## **PLANNING BOARD REPORT PORTLAND, MAINE**

Bayside Bowl Expansion  
138 Kennebec Street  
Level III Site Plan  
Project ID #2015-230  
BOPPO, LLC., Applicant.

| Submitted to: Portland Planning Board<br>Public Hearing Date: January 26, 2016 | Prepared by: Rick Knowland, Senior Planner<br>Date: January 22, 2016 |

A public hearing has been scheduled to consider an amendment to the Bayside Bowl site plan approved by the Planning Board on June 9, 2015. The address of the site is 58 Alder Street, which occupies the entire block defined by Alder-Hanover- Kennebec-Lancaster Streets. The applicant is BoPo, LLC. The development previously received approvals for Site Plan Review including Traffic Movement Permit and B-7 Design Standards. Certain waivers from the Technical and Design Manual were also granted.

| North:<br> | Sheet No.:<br><b>6</b> |

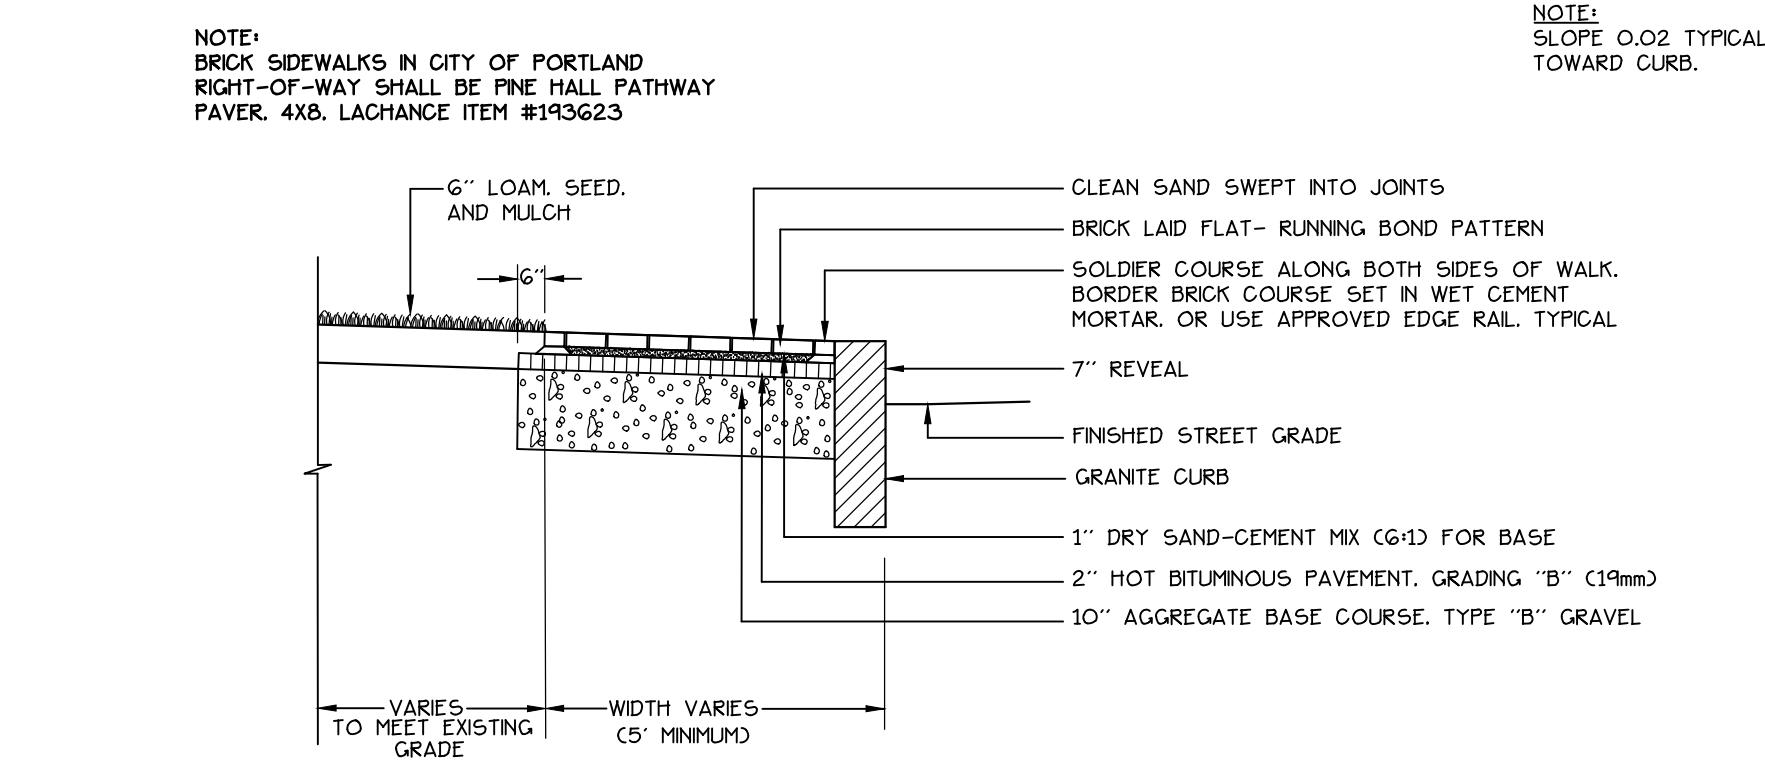
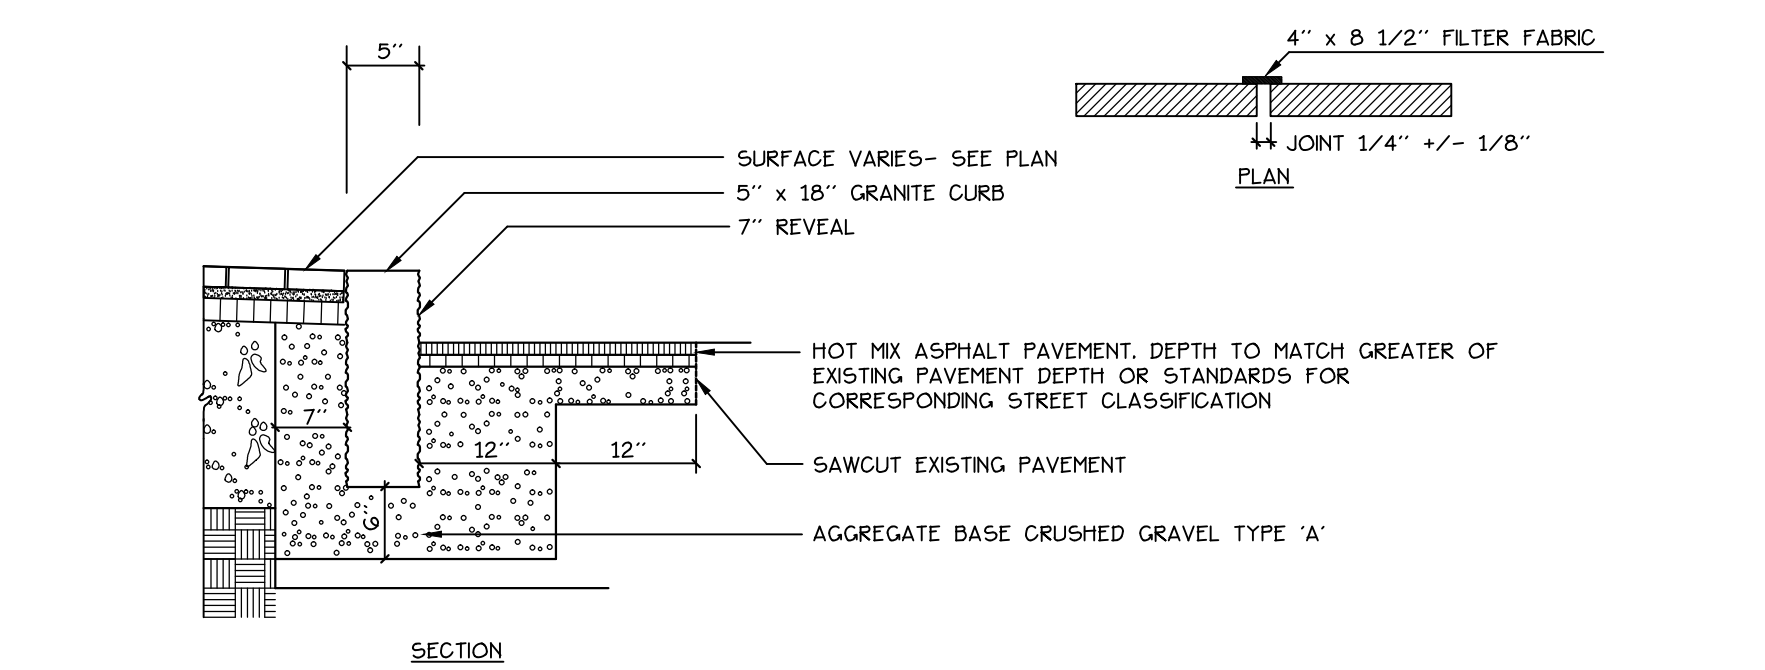
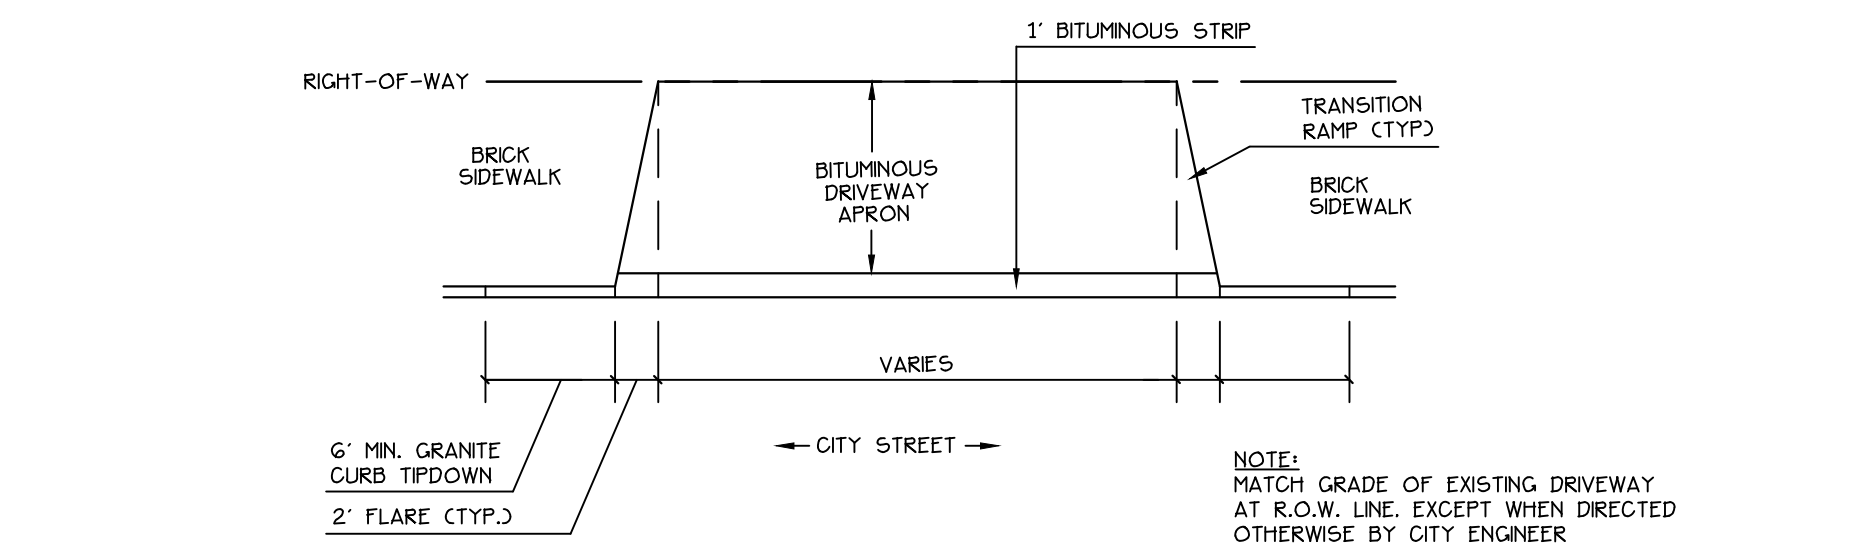
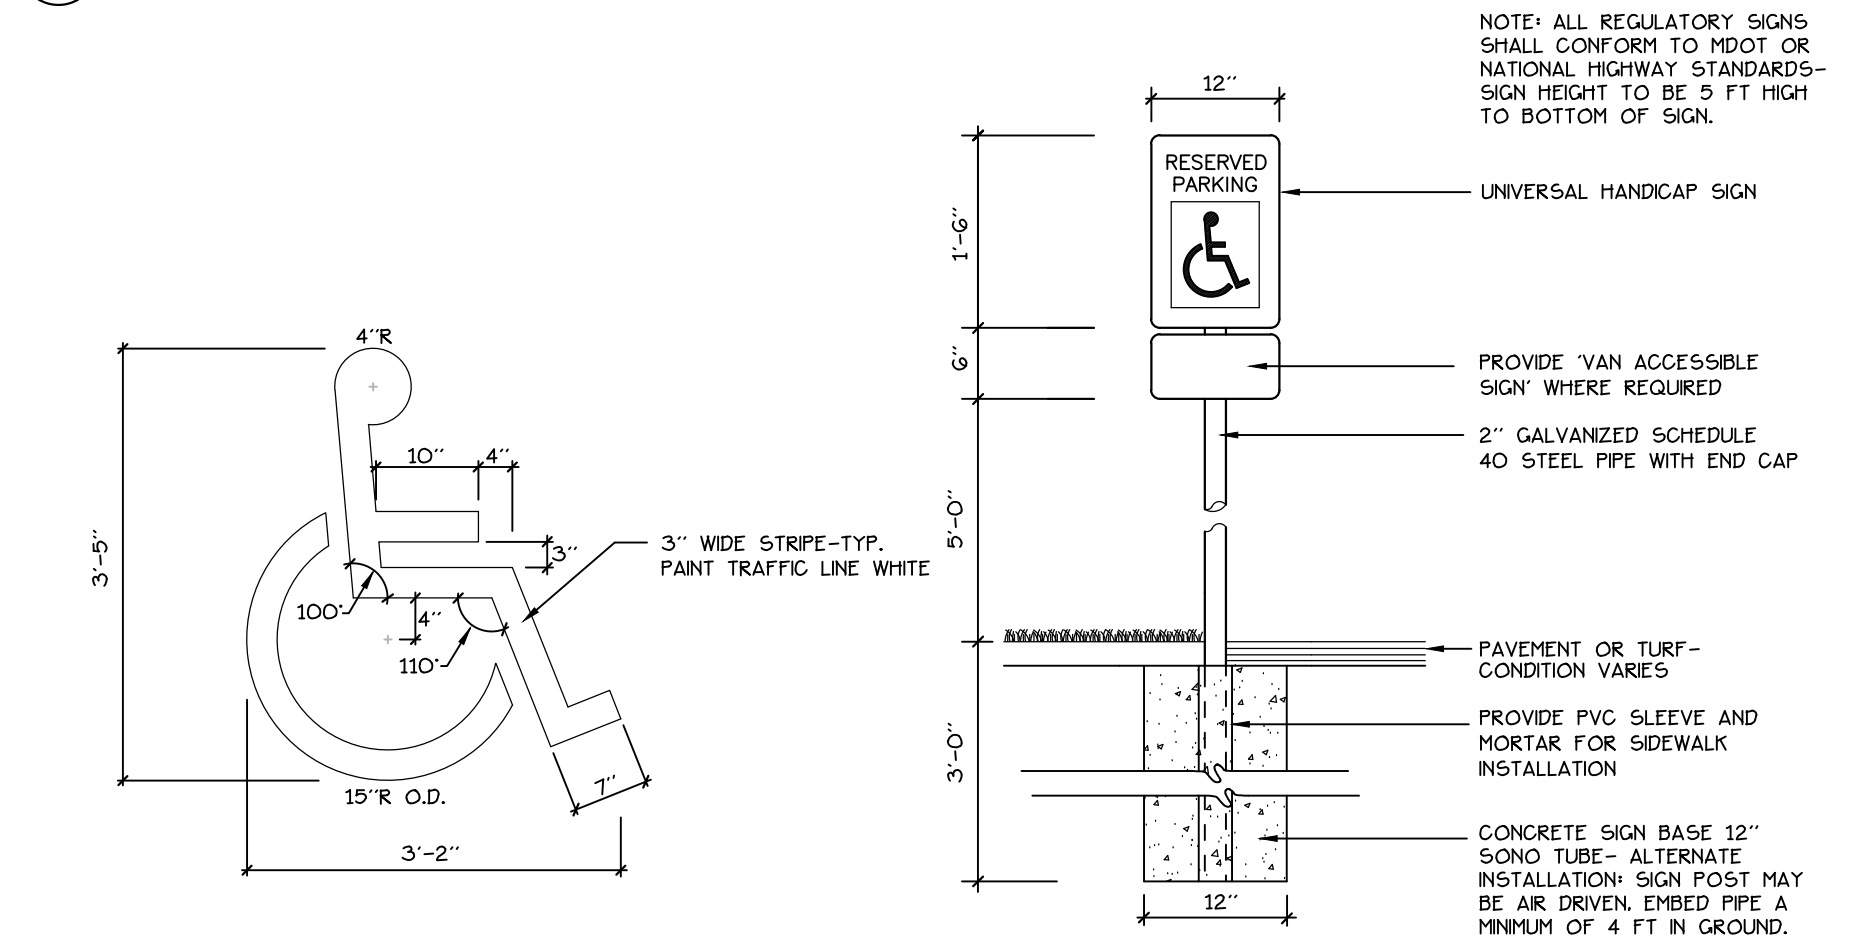
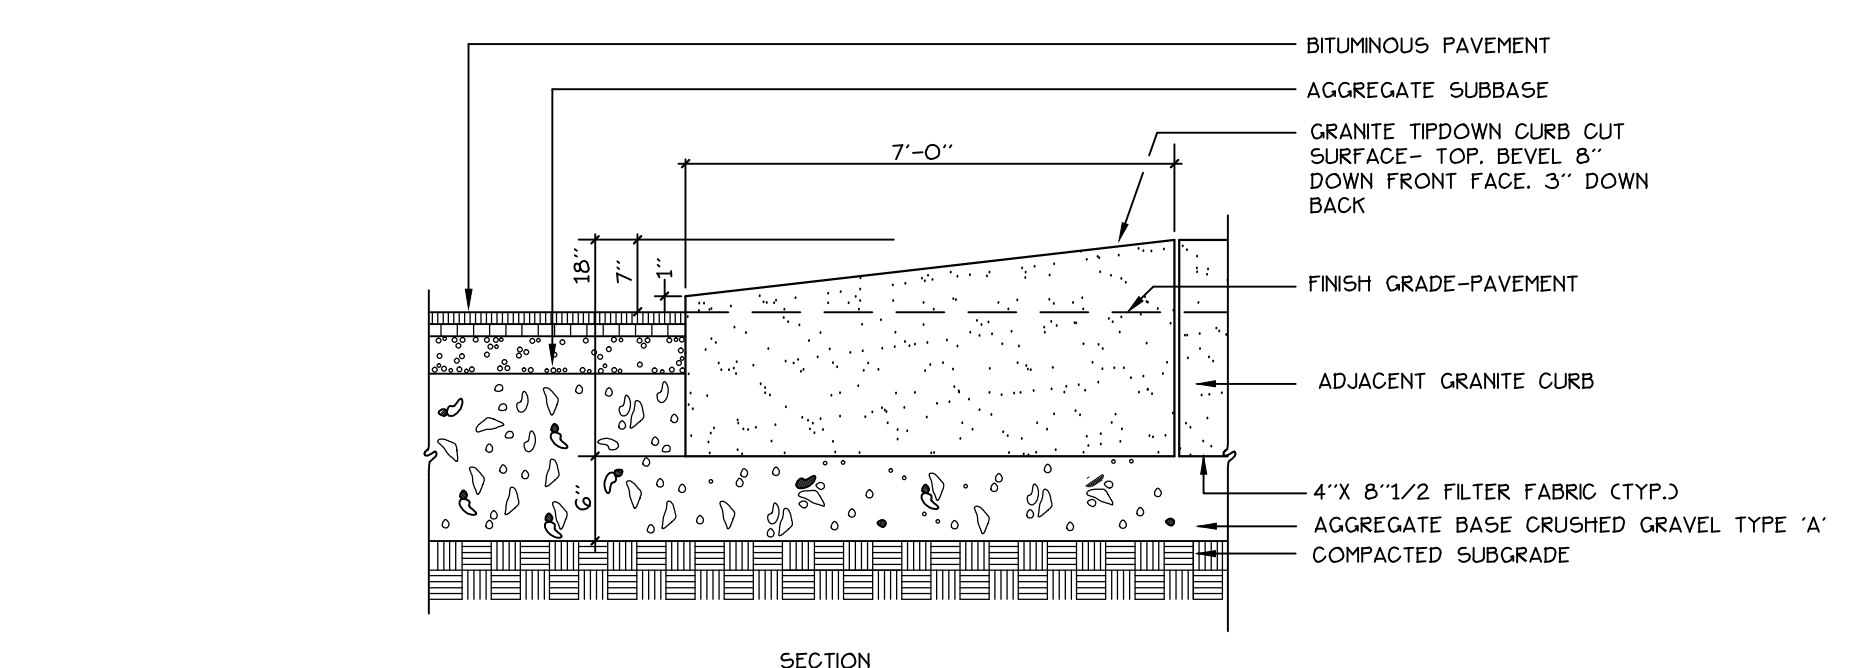
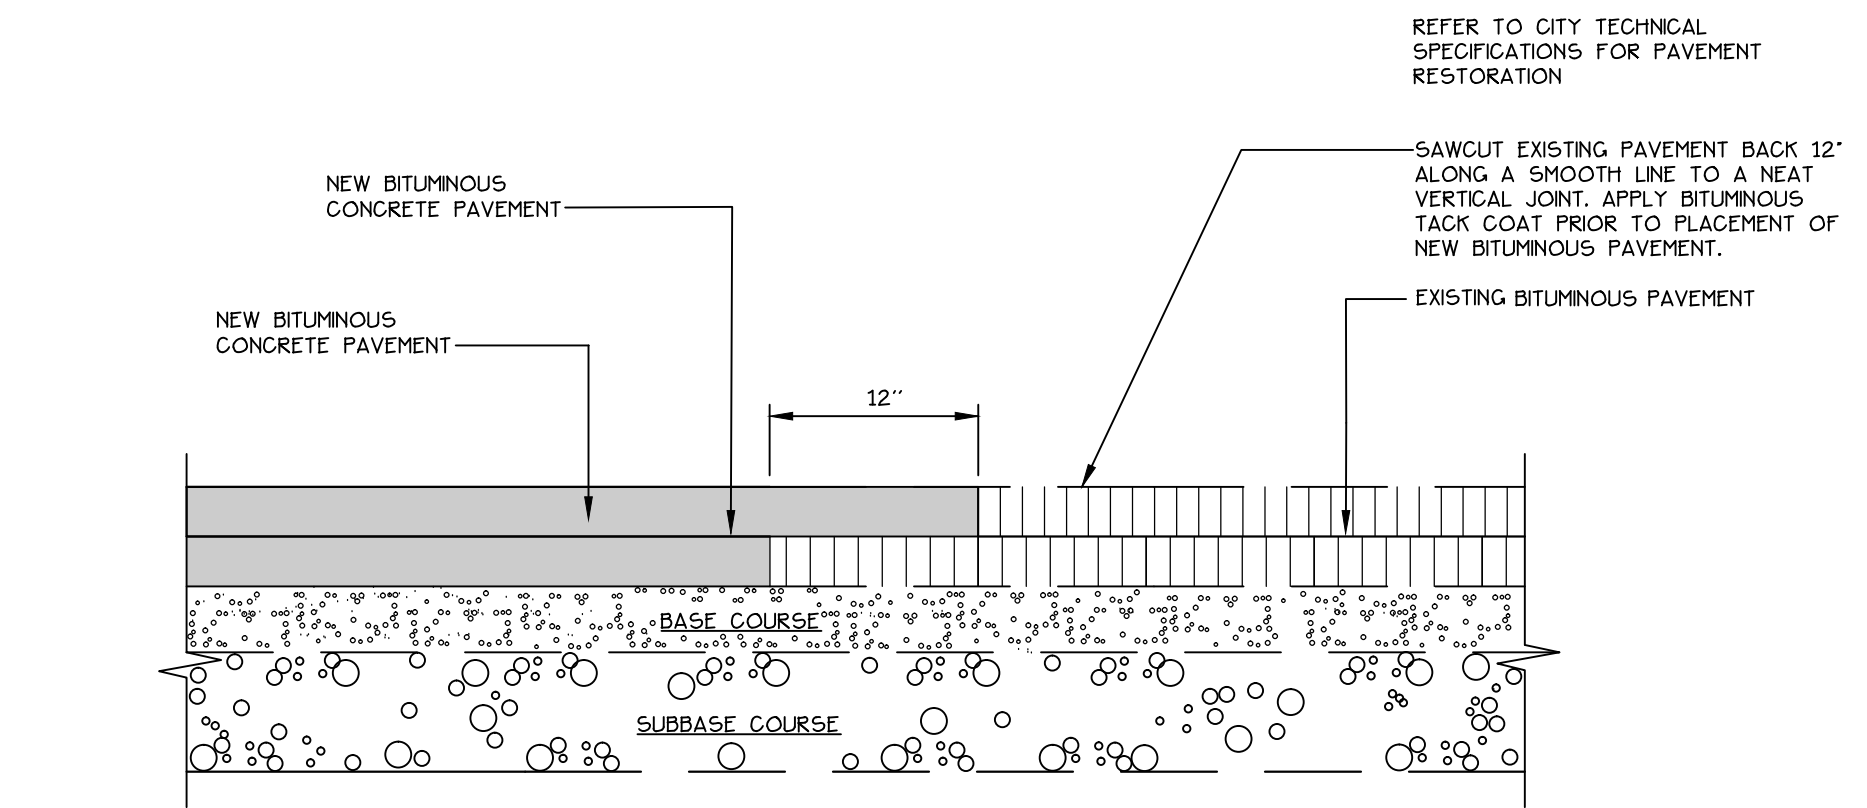
- Because the overall project will result in no new impervious area, treatment under the Maine DEP Chapter 500 Stormwater Management Standards is not required. We consider the “Stone Infiltration Trench” as depicted in Sheet 6 to suffice as an acceptable low impact development treatment system, as this detail includes a loam and sand filter system.

an area that is currently gravel. Because the overall project will result in no new impervious area, treatment under the Maine DEP Chapter 500 Stormwater Management Standards is not required. We would consider the "Stone Infiltration Trench" as depicted in the detail on Sheet 6 to suffice as an acceptable low impact development treatment system, as this detail includes a loam and sand filter layer. As such we find the project to be in compliance with the General Standards and the City's B-7 zone requirements for water quality treatment.

7

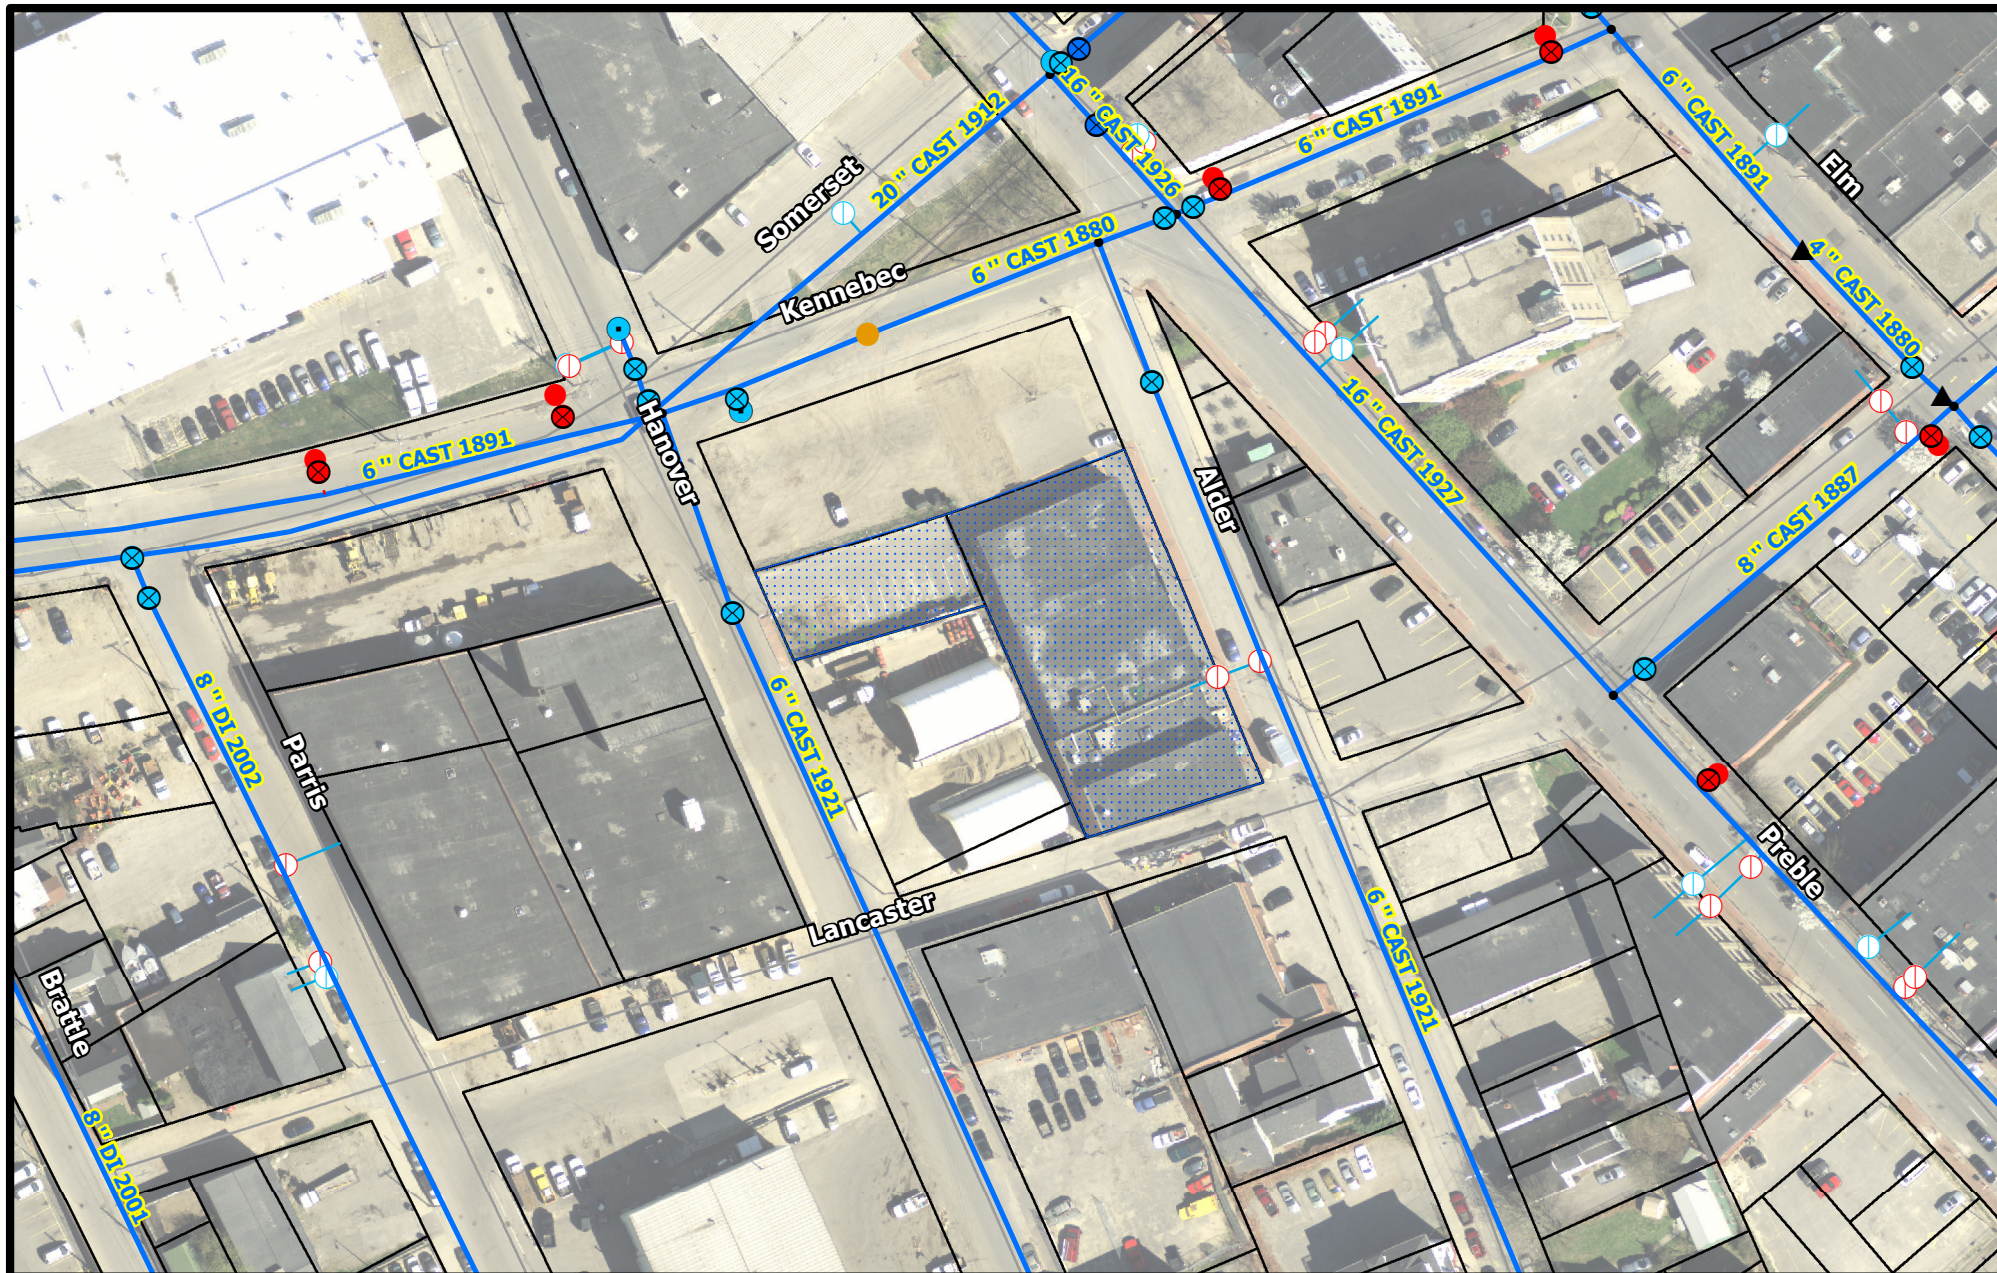
An erosion and sedimentation control plan is shown on sheet 7 of the site plan.
